1 07 03-17**Service Information Bulletin**

SUBJECT	DATE
Diagnostics	July 2017

Publication Number / Title	Platform	Section Title	Change
DDC-SVC-MAN-0140	DT12 Transmission	SPN 521732/FMI 3	Updates to existing procedures.
		SPN 521732/FMI 4	
		SPN 521732/FMI 5

45801

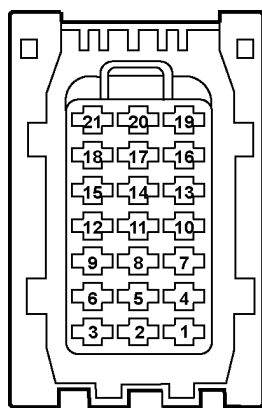
1. Was the Transmission Control Module (TCM) just replaced?
 - a. Yes; remove TCM and inspect all X3 connector mating pins for damage. If damage is found, replace component as necessary. **DO NOT ATTEMPT TO STRAIGHTEN PINS.**
 - b. No; Go to step 2.
2. Disconnect the TCM X1 21-pin connector.
3. Turn the ignition ON (key ON, engine OFF).

4. Measure the voltage between pins 1, 2, 3, 4, and 6 of the TCM X1 21-pin connector (ignition/battery voltage) and ground. Is voltage less than 11.5 volts?
 - a. Yes; restore voltage to pins 1, 2, 3, 4, and 6 of the TCM X1 21-pin connector.
 - b. No; Go to step 5.
5. Turn the ignition OFF.
6. Measure the resistance between pins 16, 19, 20, and 21 of the TCM X1 21-pin connector and the negative battery post. Is resistance greater than three ohms?
 - a. Yes; restore battery ground to pins 16, 19, 20 and 21 of the TCM X1 21-pin connector.
 - b. No; Go to step 7.
7. Are any AMT Solenoid faults (SPNs 521736 through 521752 FMI any) also present (active or inactive)?
 - a. Yes; replace the TCM and the Automated Manual Transmission (AMT) shift control unit. Clear faults after repair.
 - b. No; replace the TCM. Clear faults after repair.
